RE: ADDITIONAL INFORMATION MP05-0083 SANDY BEACH - MOD 5.

Reference is made to The Department's request for Additional Information with respect to MOD 5 of the Sandy Beach subdivision development.

Figure 1: Conceptual Layout of Proposed Water Management Structures.

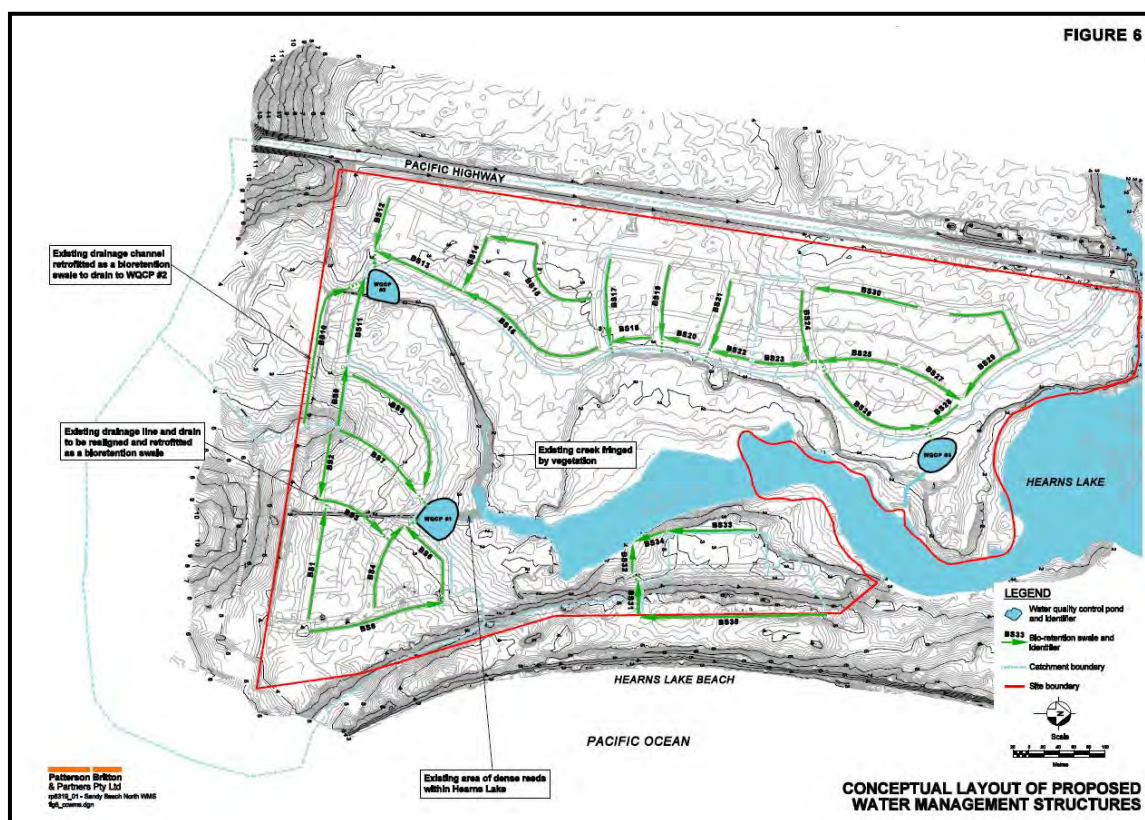
5. *Ensure the proposed changes to the stormwater management infrastructure do not increase the extent of encroachment into the Conservation Area beyond that of the stormwater infrastructure considered in the Environmental Assessment.*

Figure 6 of the Patterson Britton & Partners Drainage report “Conceptual layout of proposed Water Management Structures” reproduced (below as **Figure 1**) shows the location of proposed swales and a water quality control pond located over the existing drainage line between stages 1 and 3 on the northern side of the development footprint.

The water quality control pond proposed by Patterson Britton sits outside the nominated road reserve boundary. This facility, if constructed, would require removal of vegetation additional to what is proposed in the amended proposal. The location of the water quality control pond is as shown on the plan included as **Appendix A**.

STAGE 1 & 3 DEVELOPMENT PLAN

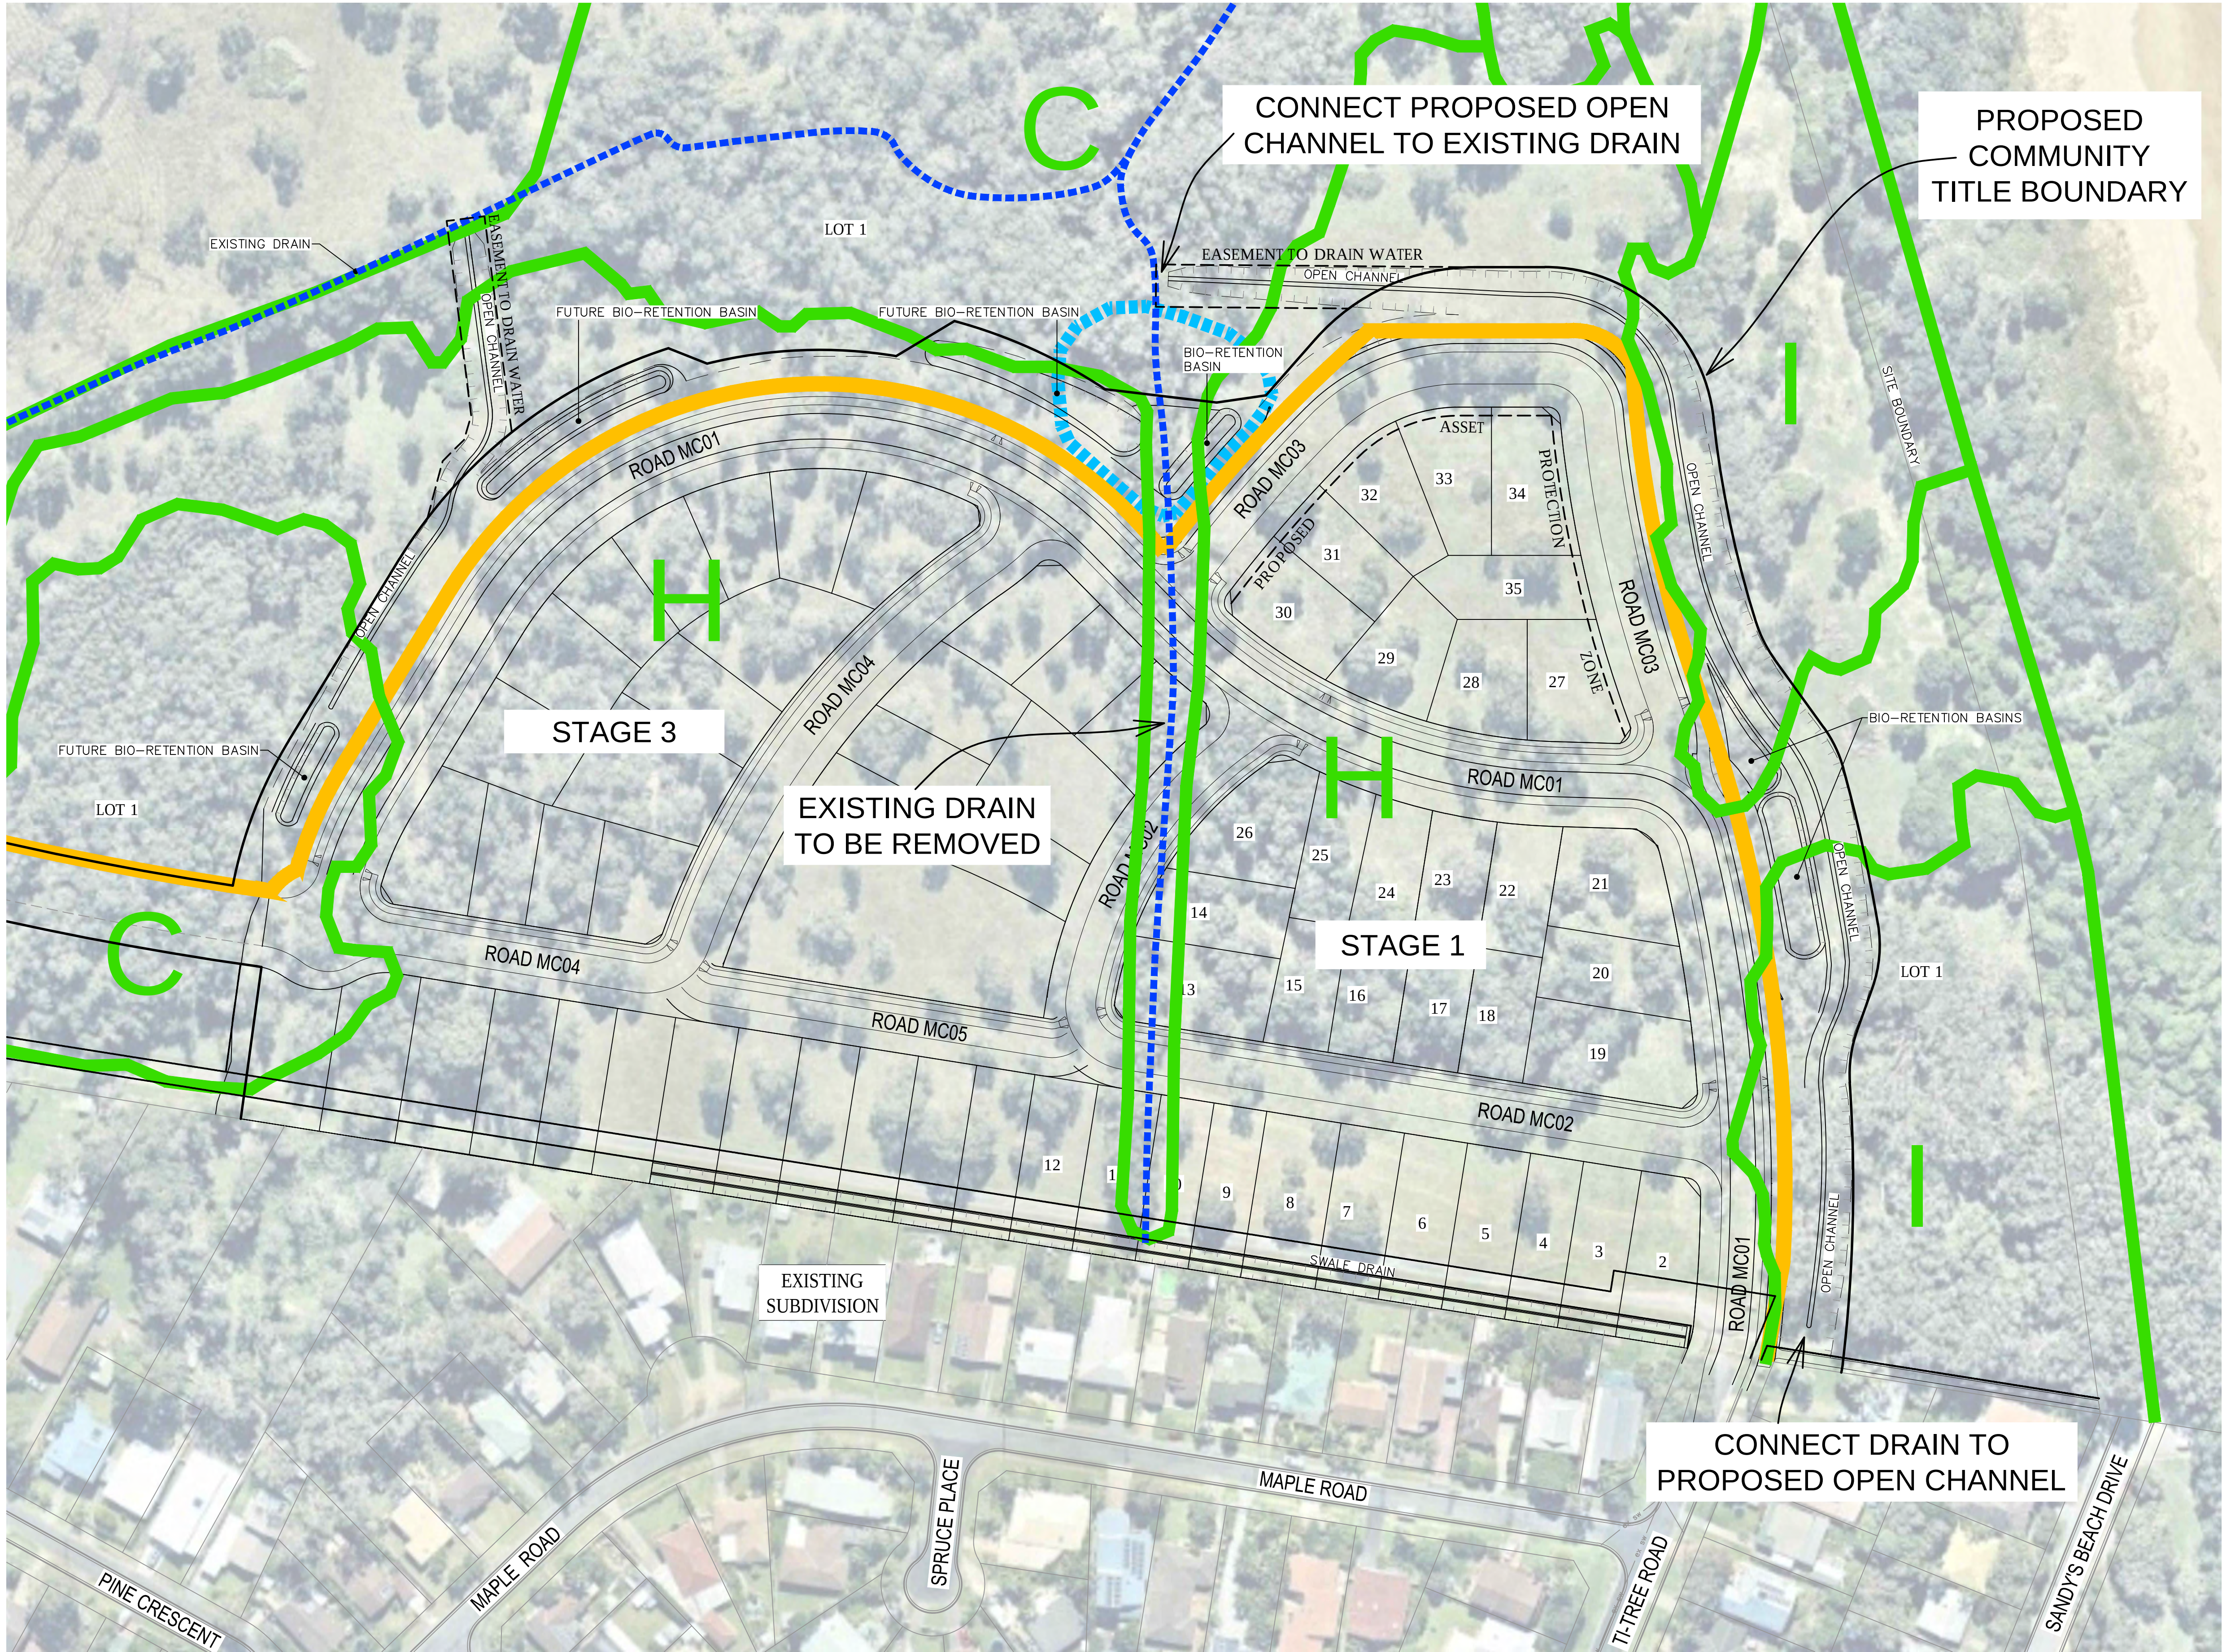
4. *Amend the modification application to include a map that compares the approved and proposed development footprint of the stormwater management facilities.*

A plan is provided as **Appendix A** for stages 1 and 3 only. This plan includes the location of the Patterson Britton water quality control ponds and facilities now proposed. As referenced above the development footprint is not shown in the concept approval. Road levels require fill batters extending beyond the edge of the road reserve and the impact of these batters needs to be considered in conjunction with the stormwater facilities. We note the level of roads was increased as a requirement of the Concept Plan Approval. While road batters will extend into the nominated Conservation Area batters will be landscaped as part of subdivision works. The proposed facilities have been located to minimise impacts and will have a reduced impact on existing vegetation when compared to the original stormwater concept.

The plan attached as **Appendix A** shows the proposed development including the stormwater infrastructure for Stages 1 and 3 overlaid on an aerial photograph. It is proposed that the drainage infrastructure will predominantly be located within the future (amended) road reserve as indicated, and drainage easements will be provided across the community lot to existing watercourses that form a legal point of drainage connection.

The impact on swamp sclerophyll forest marked as Vegetation Type C on the overlay plan (**Appendix A**) sourced from the Flora and Fauna report in the original application is considered to be less than the original proposal noting that road levels necessitate fill batters that extend beyond the edge of the road reserve and the impact of these batters needs to be considered in conjunction with the stormwater facilities.

The open channel to the east of Ti-Tree Road in the current proposal is consistent with the swale BS5, from the Patterson Britten Report. Some additional area is required for the bio retention basin however this has been located in a generally clear area to minimise any impact. The area impacted by the open channel will be landscaped mitigating vegetation loss.

Additional habitat will be provided within the open channel and bio-retention basins that will provide supplementary Wallum Froglet Habitat, The proposed water quality facilities are only 400 mm deep. The area of the water quality control facilities is 1516 m² which would be comparable to the area of the original proposal. This excludes the area of the two open channels as detailed on the plan in Appendix A.

TYPICAL OPEN CHANNEL DETAIL
N.T.S.

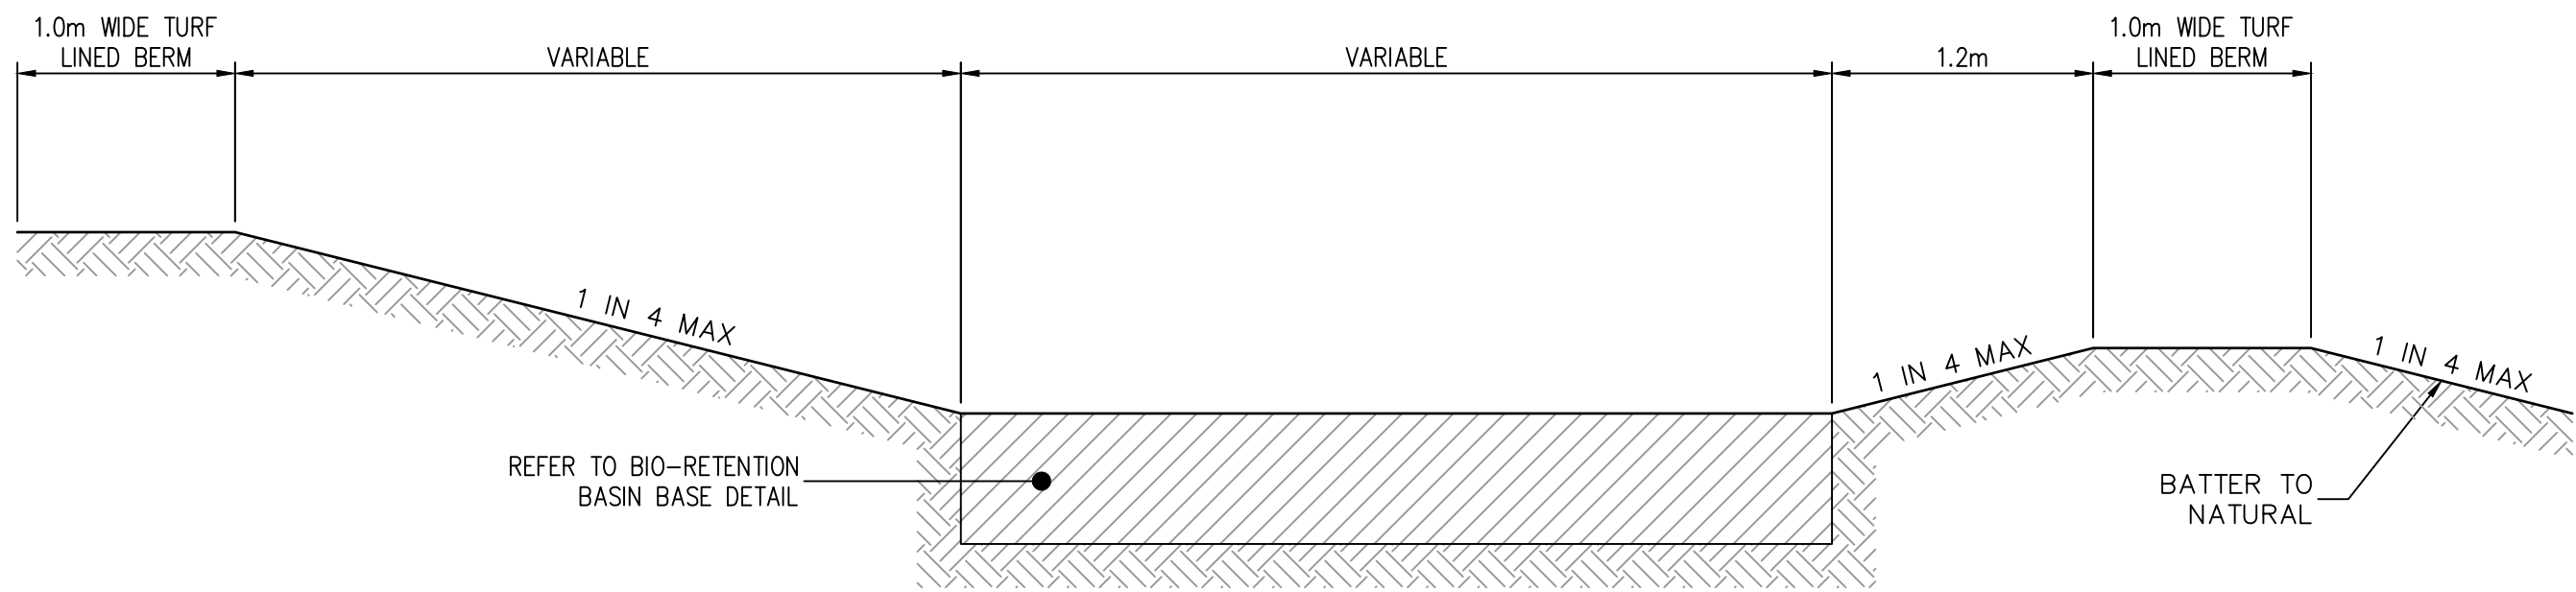
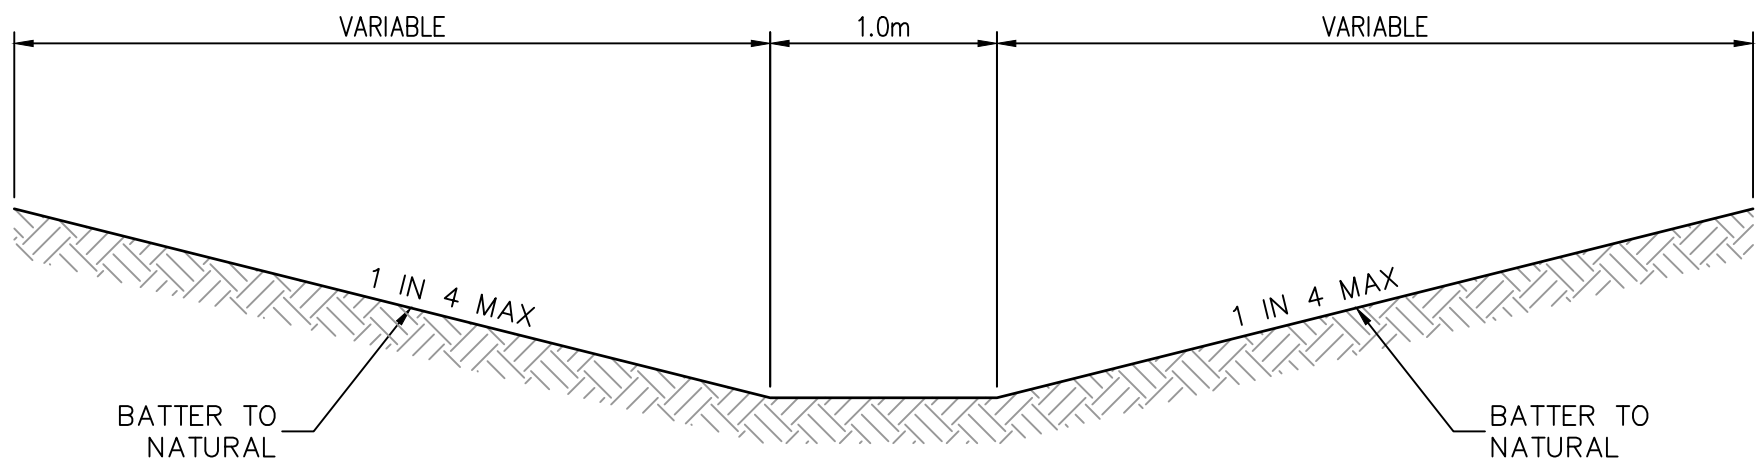
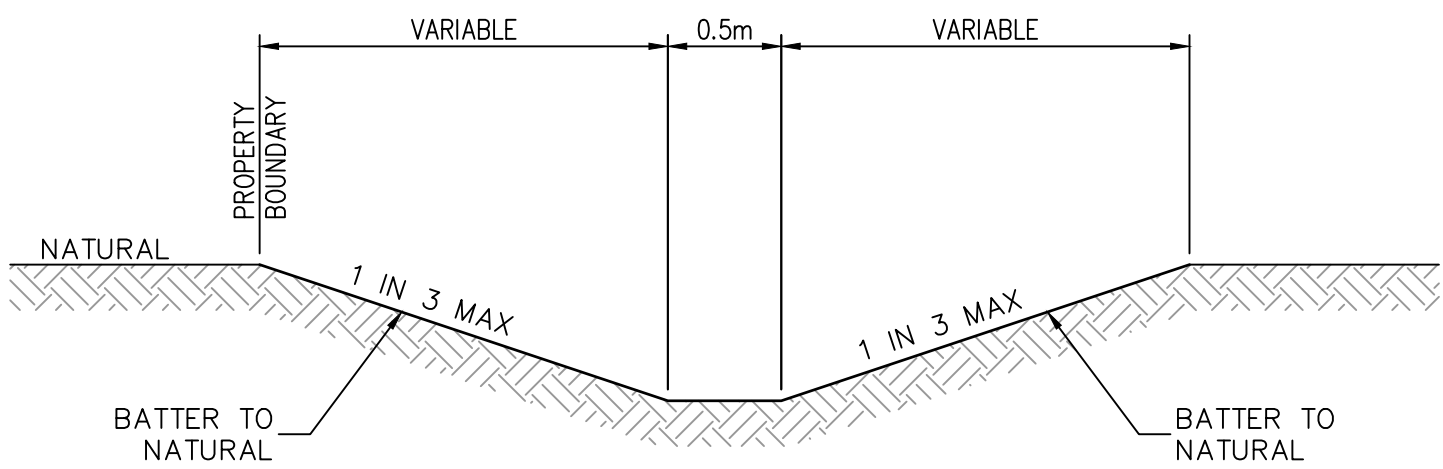
Dot Point 1 - *The existing site has a Council maintained concrete dish drain along the southern boundary. This dish drain currently discharges stormwater from the existing road network (utilising a piped network that traverses through Lot 524 in DP 227298, within a drainage easement), Ti-tree Road and Sandy Beach Road, and discharges north through the development site. The proposed modification changes the concrete dish drain to a grass swale, reverses its grade, subsequently its depth where it discharges near the eastern boundary prior to heading north. It is observed from the plans that the discharge point is*

relocated approximately 250m east, where the ground elevation is approximately 1m higher than the existing discharge point. Council is concerned about the depth of the new swale drain and the downstream infrastructure that will be required to be maintained by Council.

The open channel as detailed in the engineering plans will be constructed with a 1.0 metre wide base and 1 in 4 sides that will be plated with native grasses with occasional tree planting and require minimal maintenance. We note the Patterson Britton drainage strategy included a swale (BS5) on the outside of the extension of Ti-Tree Road as indicated in **Figure 1** below. With respect to flood impacts the development is downstream of existing development and drainage from the existing development is being collected and managed through the site. Stormwater Detention will be provided within proposed drainage facilities to mitigate impacts as referenced above in the response to OEH's concerns.

The design of the open channel has been undertaken to cater for the existing drainage discharged onto the subject site via piped drainage easement from Maple Road through Lot 524 DP 227298, discharge from Ti-Tree Road and from Sandy Beach Road. The critical level of the channel is governed by the piped drainage network within Ti-Tree Road not the level of the piped drainage easement through Lot 524. The existing piped drainage system catering for the existing development within Ti-Tree Road and Maple Road is located on the western side of Ti-Tree Road, see attached **Photo 1**. In order to discharge this drainage through the subject site it is required to be done via a swale at a grade of 0.3%. The option of extending the drainage within a piped system was explored however Council design standards and supporting industry documentation does not support a piped drainage network at 0.3%. The level, depth and therefore width of the swale is controlled by the existing drainage system, see attached **Photo 1**, by installing a new pit and extending the drainage system under Ti-Tree Road. In order to maintain adequate cover over the new pipe network the swale drain is required to be at the depth currently depicted.
